**City of Portland, Maine - Building or Use Permit Application**

**BUILDING PERMIT REPORT**

DATE: 24 August 2001 ADDRESS: 39 Alderbrook Road CBL: 085-M-013  
 REASON FOR PERMIT: To Construct a single family dwelling  
 BUILDING OWNER: Carolyn S. Gill  
 PERMIT APPLICANT: \_\_\_\_\_ /CONTRACTOR SAO  
 USE GROUP: R-3 CONSTRUCTION TYPE: 5B CONSTRUCTION COST: \$160,000 PERMIT FEES: \$984.00

**CITY OF PORTLAND, ME  
BOCA 1999 Plan Review Record  
One and Two Family Dwelling**

SHEET TITLE  
**ELEVATIONS**

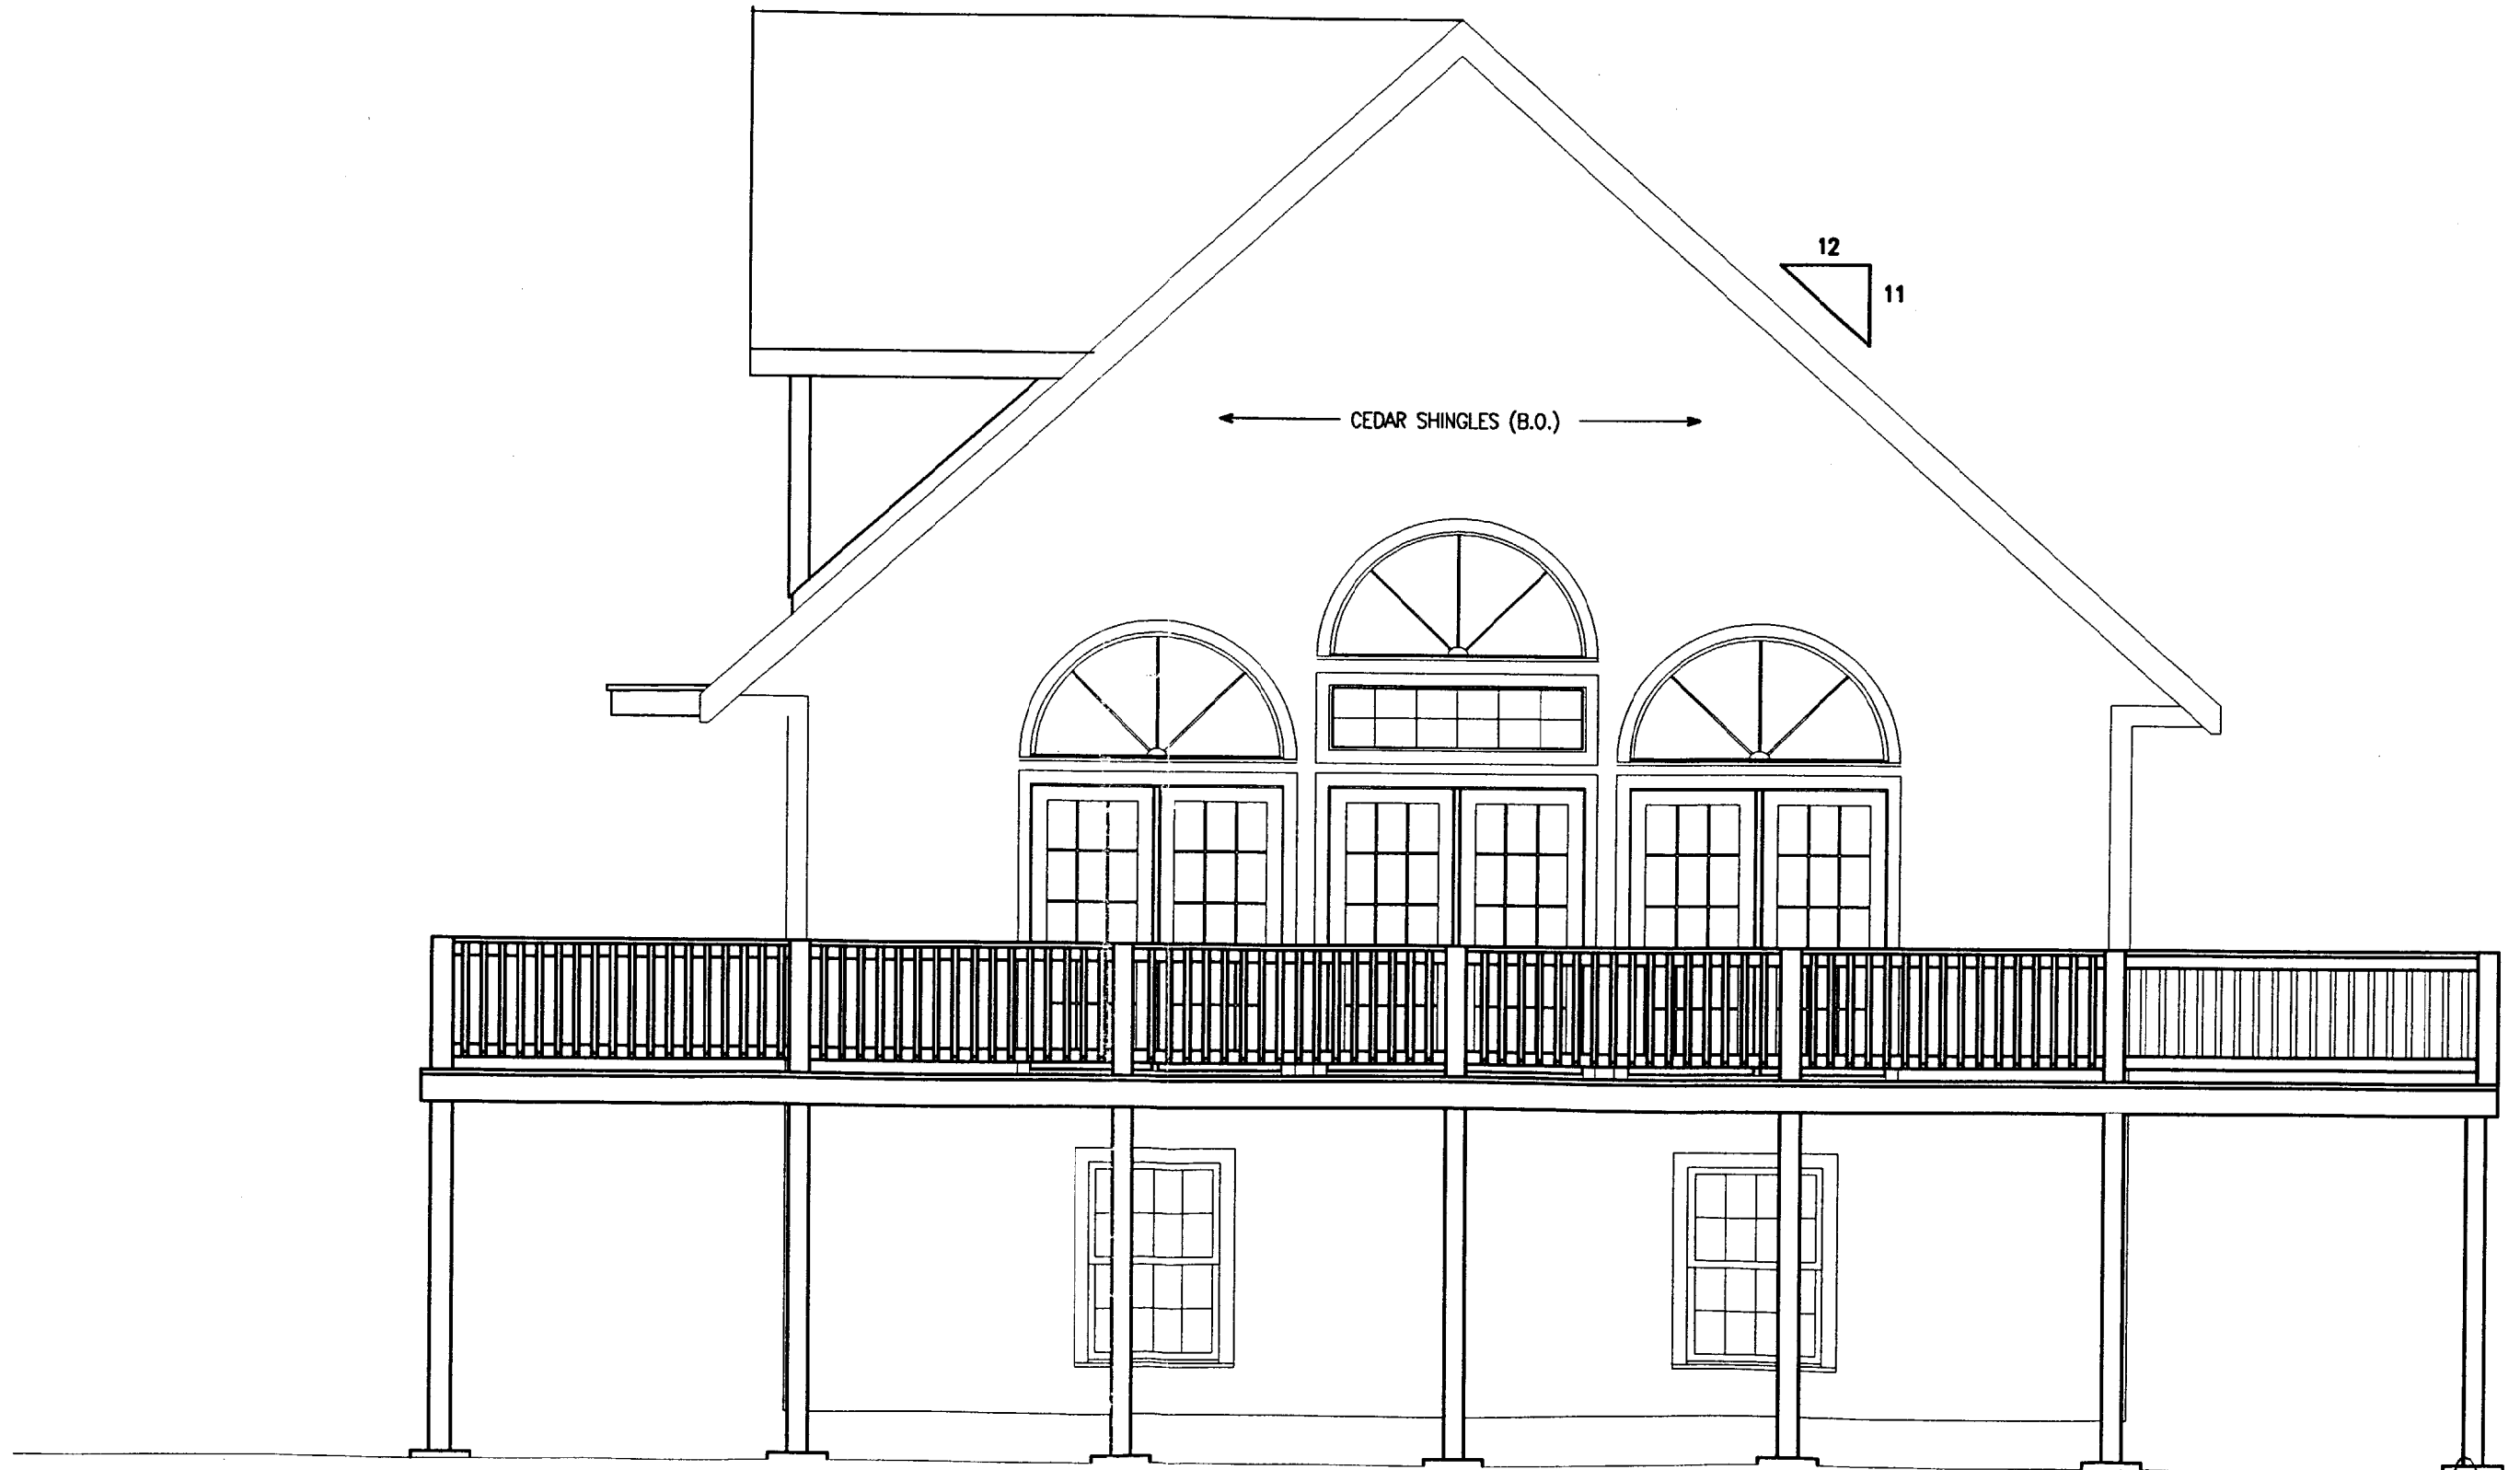
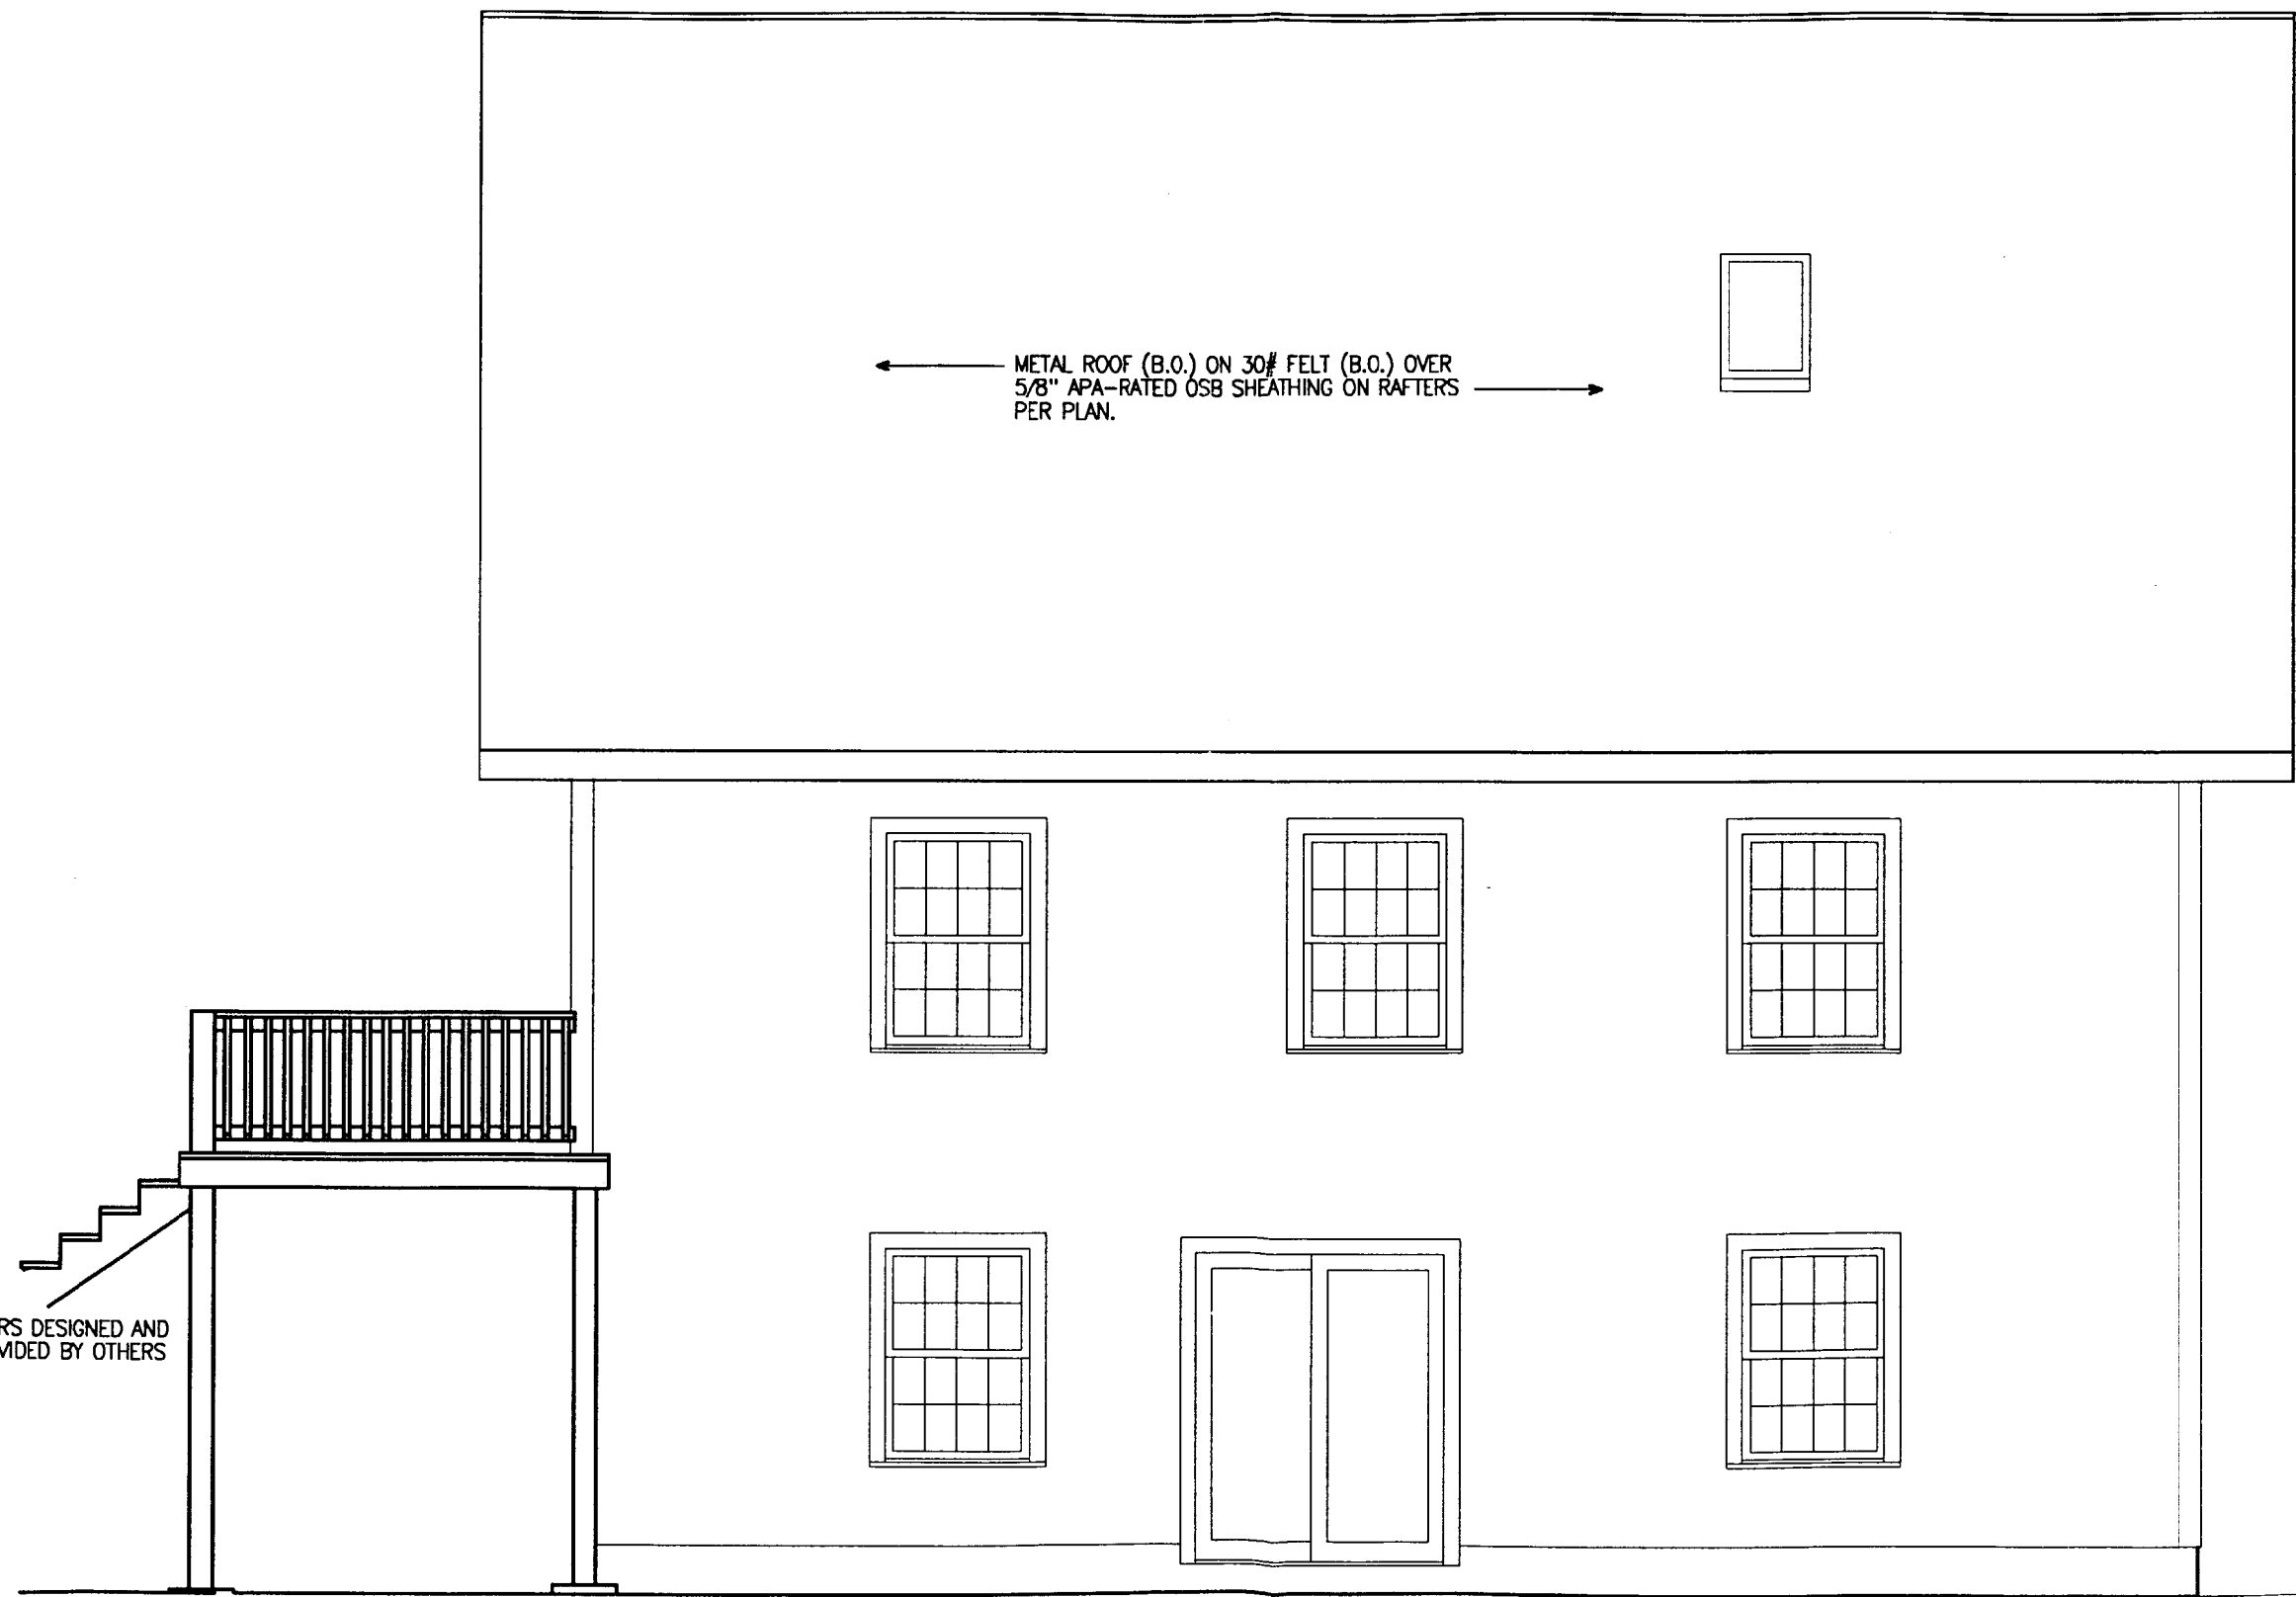
8/21 Revised  
larger Plans  
DC
